MEMO

DATE: December 1, 2015

SUBJECT: VA White City – Building 201B: Chiller & Dry Cooler Environmental Noise Mitigation

Figure 1: Option 1 - Noise Mitigation Plan

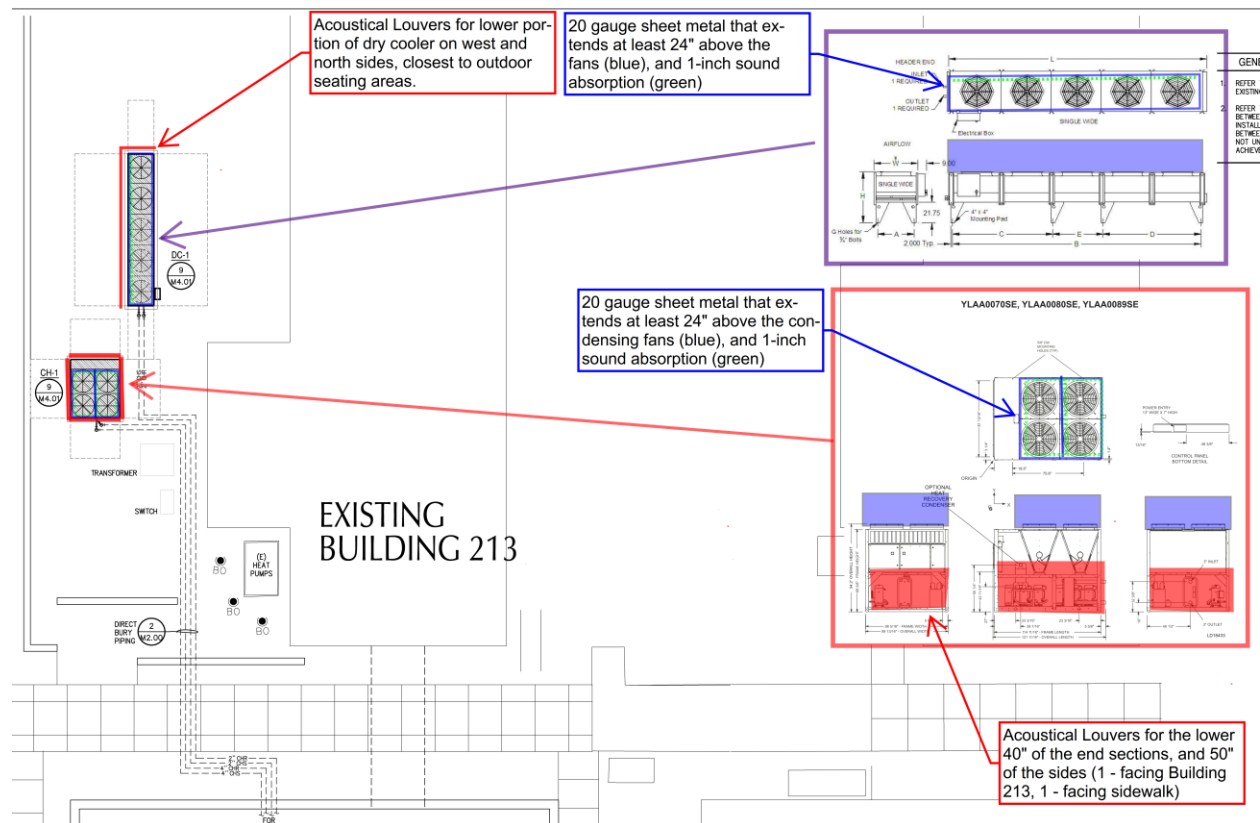
This noise reduction plan would provide the same improvement to outdoor areas as well as the exterior envelope of Building 213. Estimated noise reduction of 6 to 8 dBA, for a predicted level for outdoor seating of 59 dBA with both systems operating at 100%, which is clearly audible, but quiet enough to have a phone conversation.

1. Install 6-inch deep acoustical louvers for the bottom 40-inches for the ends of the chiller, bottom 50-inches for sides of chiller, and bottom of plan north and west sides of Dry Cooler, highlighted red on Figure 1.
 - a. Products: [Pottorff](#) EAA-645, [Greenheck](#) AFJ, [Vibro-Acoustics](#) ALA-HV-6
2. Install 20-gauge sheet metal that extends 24-inches above the condensing fans (shown in blue on Figure 1. Install sound absorptive liner to the inside face of the sheet metal to reduce reflected sound.
 - a. Sound Absorption options:
 - i. 1-inch thick [Sealed Air Stratocell Whisper](#)
 - ii. 1-inch thick [Armacell Armaflex AP](#)
 - iii. 1-inch thick Polyester ([F-Sorb](#)) on ½" thick vertical hat channel

Figure 2: Option 2 – Noise Mitigation Plan

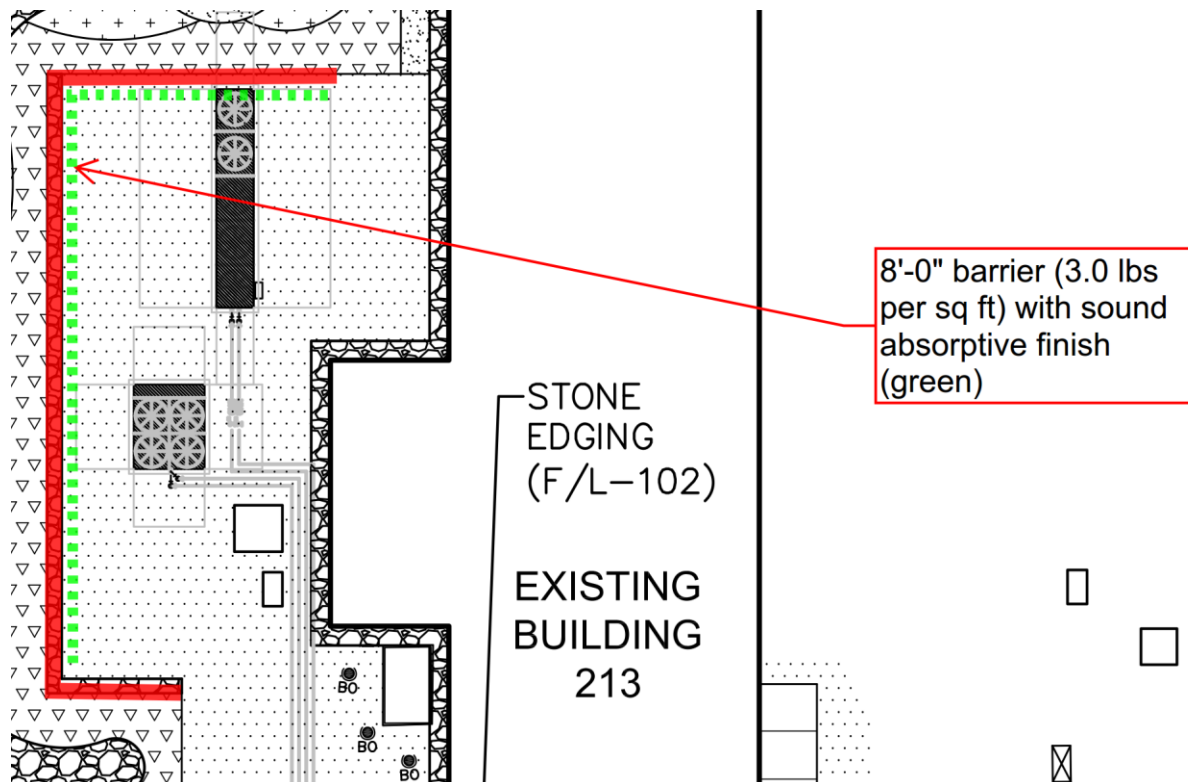
This noise reduction plan would provide improvement to the outdoor areas and little reduction to Building 213. Estimated noise for outdoor seating is 55 dBA with both systems operating at 100%, which is clearly audible, but is quiet enough to have a phone conversation.

1. Install 8'-0" high barrier that has a minimum surface weight of 3.0-lbs per sq ft.
 - a. Material Options: 3/4-inch exterior grade plywood, 5/8-inch cement board or cement siding, 20 gauge sheet metal with 1-inch cementitious commercial fireproofing spray.
 - i. 1-inch fireproofing spray is sound absorptive (noted below), and ensures the metal panels meet surface weight requirements
2. Install sound absorption for the inside face of the west and north portion of the barrier from 2'-0" to 8'-0".
 - a. Sound Absorption options:
 - i. 1-inch thick low density fireproofing spray or Vermiculite and Portland Cement spray
 1. [Pyrok Acoustement40](#)
 2. [Cafco Sound-Shield 40](#)
 3. [Grace Monokote MK-6](#)
 - ii. Or one of the following materials on 1-inch vertical furring strips
 - a. [Sealed Air Stratocell Whisper](#)
 - b. [Armacell Armaflex AP](#)
 - c. [F-Sorb](#)

1 SITE PLAN - MECHANICAL EQUIPMENT
SCALE: 1/8"=1'-0"

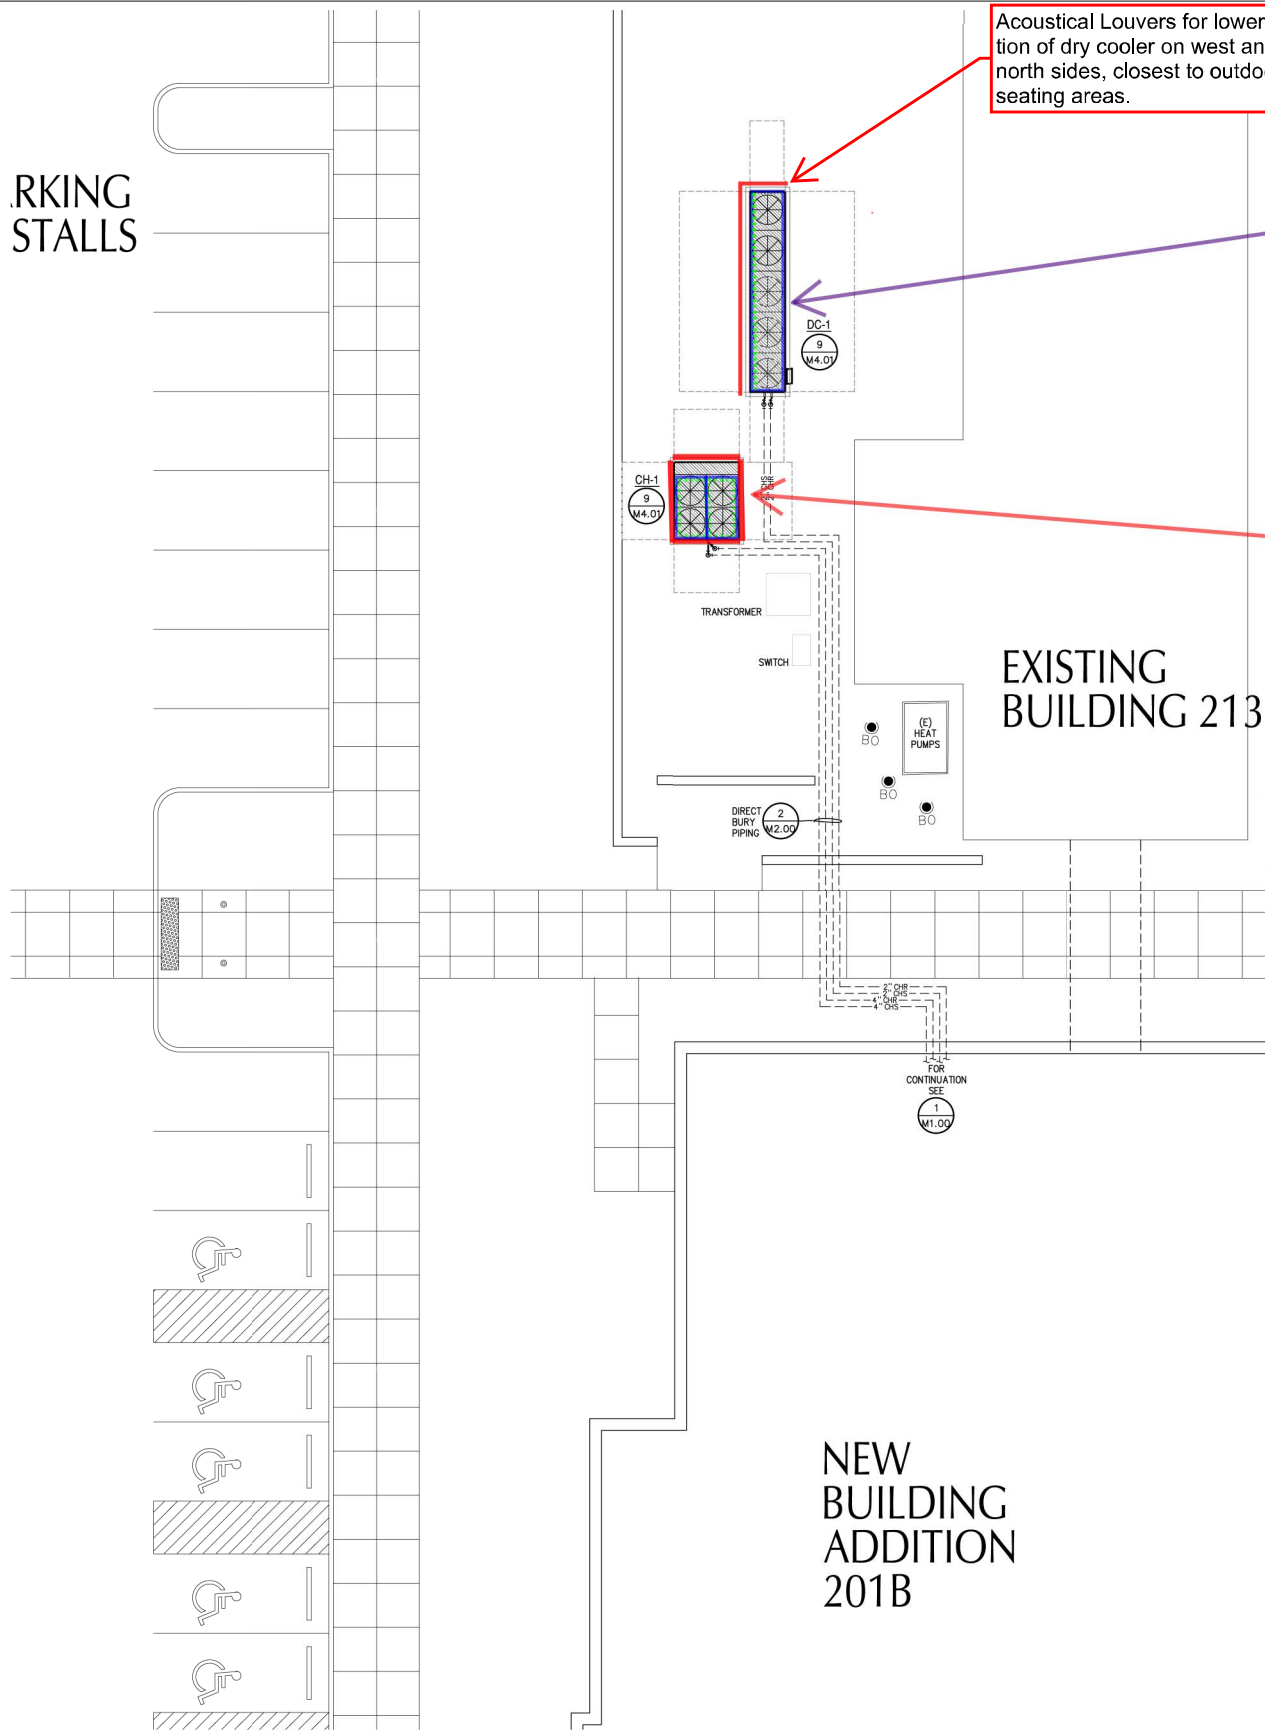
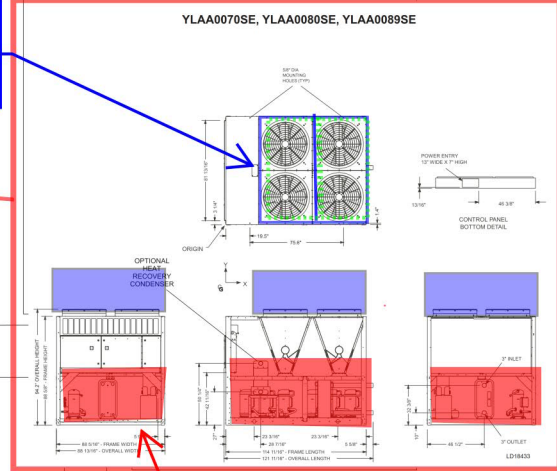
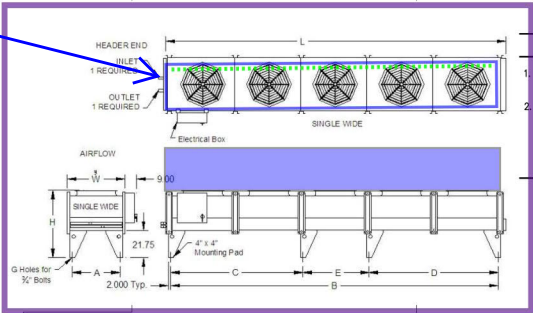
Acoustical Louvers for lower portion of dry cooler on west and north sides, closest to outdoor seating areas.

20 gauge sheet metal that extends at least 24" above the fans (blue), and 1-inch sound absorption (green)

20 gauge sheet metal that extends at least 24" above the condensing fans (blue), and 1-inch sound absorption (green)

Acoustical Louvers for the lower 40" of the end sections, and 50" of the sides (1 - facing Building 213, 1 - facing sidewalk)
